OFFICIAL STAR CLASS MEASUREMENT CERTIFICATE

Yacht No. 2087

1. YACHT'S NUMBER? 2087
2. Was this number cut or burned into keelson as required above? YES
3. Yacht's name "NASSAU STAR" 4. Year built? 1941
5. By whom built? CHAS. MUNRO
6. Owner's name? R.H. + R.T. SYMONETTE
7. Address NASSAU BAHAMAS
8. Fleet NASSAU 9. Remarks

Stations	1.	2.	3.	4.	5.	6.	7.	8.	9.	10.
Contour	$19\frac{1}{8}$	$15\frac{1}{8}$	$9\frac{1}{4}$	$5\frac{7}{8}$	$2\frac{7}{8}$	2	$3\frac{1}{4}$	$6\frac{7}{8}$	11	$15\frac{3}{8}$
Chine			$11\frac{1}{4}$			$7\frac{1}{8}$		$10\frac{1}{2}$		17
Side			$21\frac{1}{4}$			$21\frac{1}{4}$		$17\frac{1}{2}$

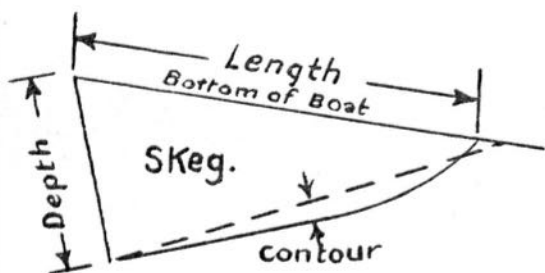
Relative to Stars #2087 and #2088 I will appreciate a recheck of Contour Height at Stations Six and Two. Please check your instructions carefully regarding measuring at Station Six so that this is taken accurately. In the case of your own boat, I suggest that you have a witness enclose a statement signed by him.

$\frac{1}{3}\frac{13}{16}$ Heights.

$2\frac{1}{4}$ for little 5/23/47

At Station Two I found the
height to be $13 \frac{13}{16}$ ". At Station Six I had a
hole drilled and then subtracted standard planking
from the inside measurement. I then got $2 \frac{1}{4}$ " as
a measurement at this point. I kept no copy of the
other measurements so I have no idea how they
check out.
